Subject ► Change on ball bearing, etc.

For Models ► 6904VH, 6904H (Impact Wrench) and 6904V (Impact Driver)

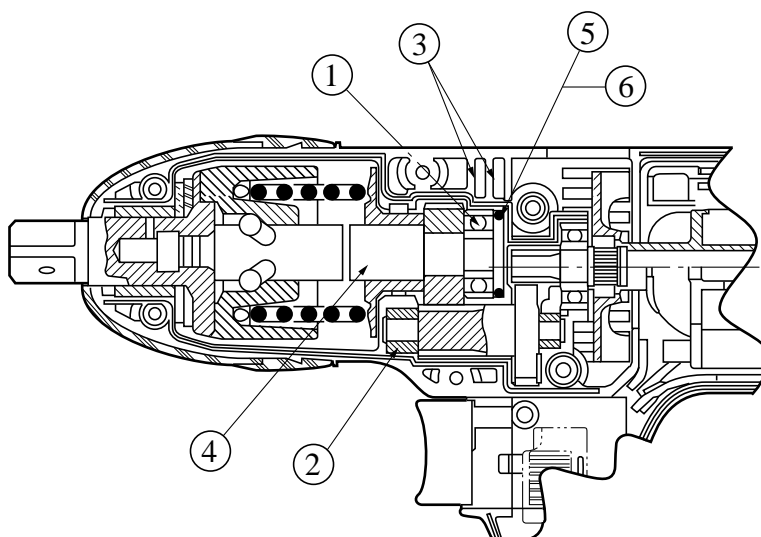
- Description** ►
1. The ball bearing 608VV with outer diameter 22 mm (7/8") will be re-placed by a ball bearing 609LLB with outer diameter 24 mm (15/16").
 2. The plane bearing 6 will be changed from 10 mm (13/32") to 12 mm(15/32") in outer diameter.
 3. The housing will be changed as follows.
 - i) Ribs will be added to the portions around the bearings.
 - ii) The dimensions of portions to accept the bearings will be changed.
 4. The portion of spindle to be inserted into the ball bearing will be changed from 8 mm (5/16") to 9 mm (11/32") in diameter.
 5. The flat washer 16 will be replaced by a flat washer 18.
 6. The O ring 17 will be replaced by an O ring 20.

The above Nos. corresponds to the item Nos. shown in the figure below.
